# Work Order ID 97966

Item Name: Head Rest

DRAWING NO. D3303	TITLE HEAD REST	REV. B	<b>DART AEROSPACE LTD ENGINEERING ORDER</b>		D.E.O. NO. D3303-B-1	SHEET NO. SHEET 1 OF 1	SCALE NTS
DRAWN AJS	CHECKED <i>h</i>	MFG. APPR. <i>h</i>	APPROVED <i>h</i>		DE APPR. <i>h</i>		
DATE 08.10.15	DATE 08.10.15	DATE 08/10/16	DATE 08/10/16		DATE 08/10/16

**D3303-041 HEAD REST**

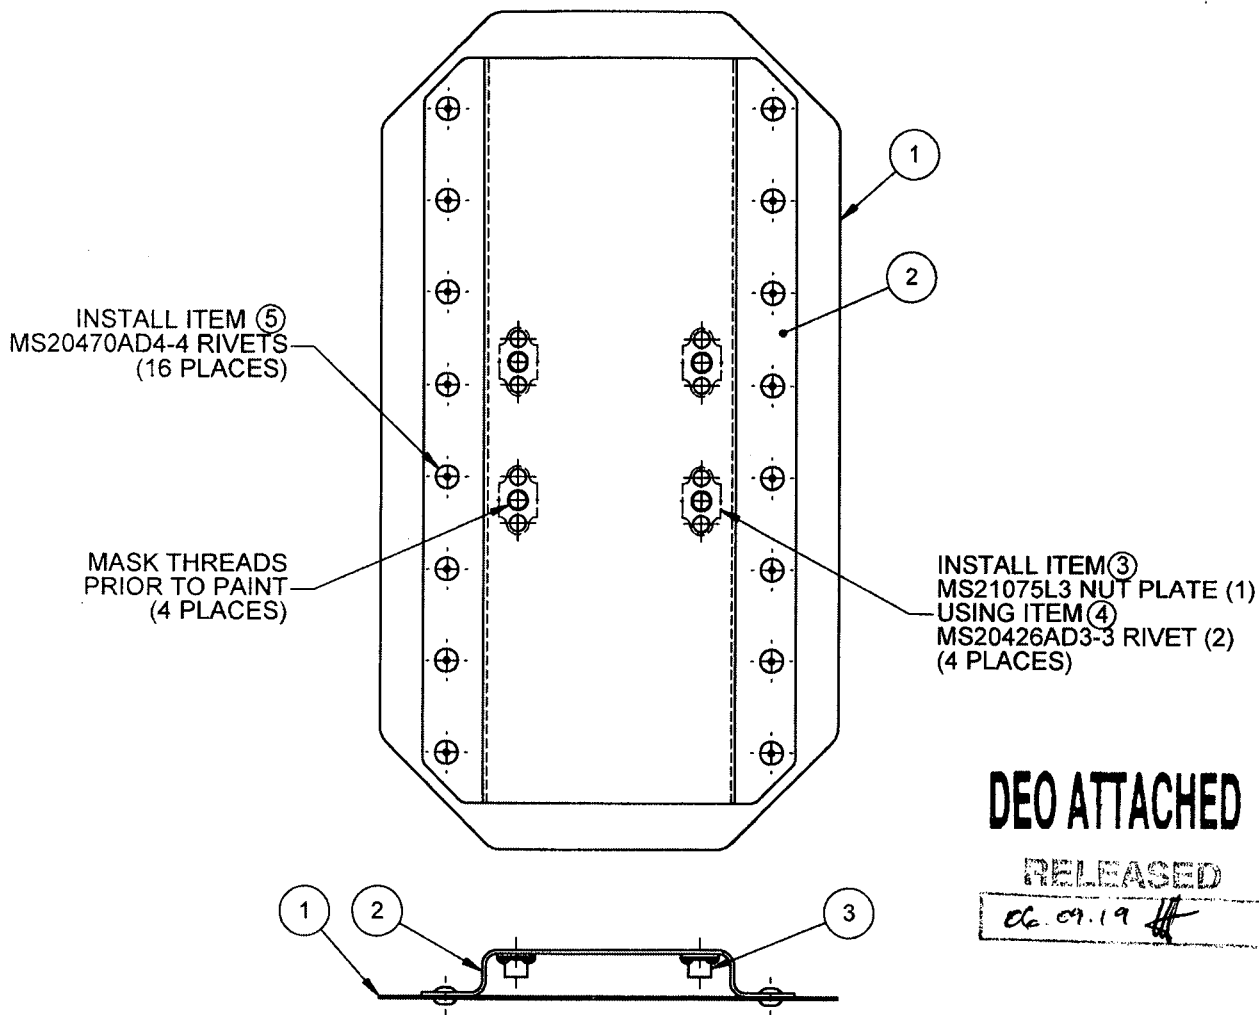
SHEET 1 ADD 1300L ADHESIVE BY 3M TO NOTE 1 AS FOLLOWS:

**WAS:**

- 1) BOND D3305-1 FOAM TO D3303-043 BRACKET ASSEMBLY USING 3M 1300 ADHESIVE (0.002" TO 0.010" THICK) IN ACCORDANCE WITH MANUFACTURER'S INSTRUCTIONS

**IS:**

- 1) BOND D3305-1 FOAM TO D3303-043 BRACKET ASSEMBLY USING 3M 1300 OR 1300L ADHESIVE (0.002" TO 0.010" THICK) IN ACCORDANCE WITH MANUFACTURER'S INSTRUCTIONS

SEE NCR 08-069 FOR FURTHER DETAILS
